GLOBAL SAFETY FIELD INVESTIGATIONS
DCS6355
URGENT - DISTRIBUTE IMMEDIATELY

Date: December 6, 2022
Subject: N222387720 - Service Update
Outer Body Panel Split
Models: 2023 Cadillac XT6
To: All General Motors Dealers

N222387720 Outer Body Panel Split

6203023

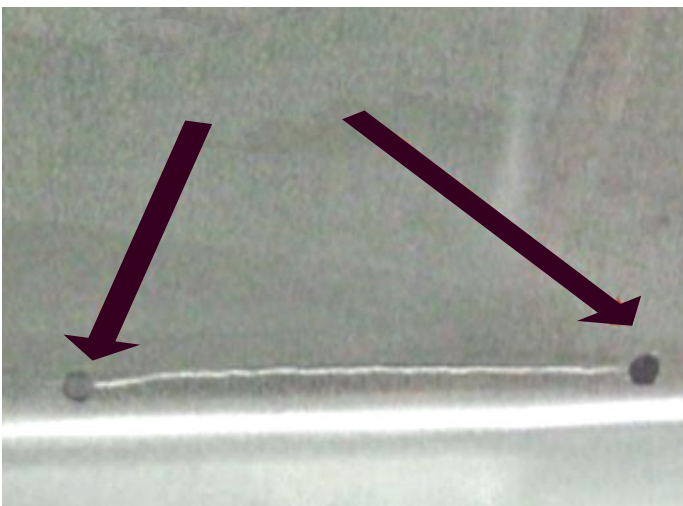
- Carefully inspect the area above the left quarter panel window for a cracking condition. This condition will be directly above the glass to body seal.

- If no cracking condition is found, no further action is required.
 - If a cracking condition is found, proceed to step # 2.
2. Remove the left quarter panel glass. Refer to *Quarter Window Replacement* in SI.
 3. Remove the left front, rear and 3rd. row roof rail airbag from the work area, it is not necessary to remove the complete assembly. Refer to *Front, Rear, and 3rd Row Roof Rail Airbag Replacement* in SI.
 4. Remove the left rear body structure stop lamp. Refer to *Rear Body Structure Stop Lamp Replacement* in SI.
 5. Move any wiring or flammable insulation from the inside of the repair area.
 6. Disconnect the negative battery cable. Refer to *Battery Negative Cable Disconnection and Connection* in SI.
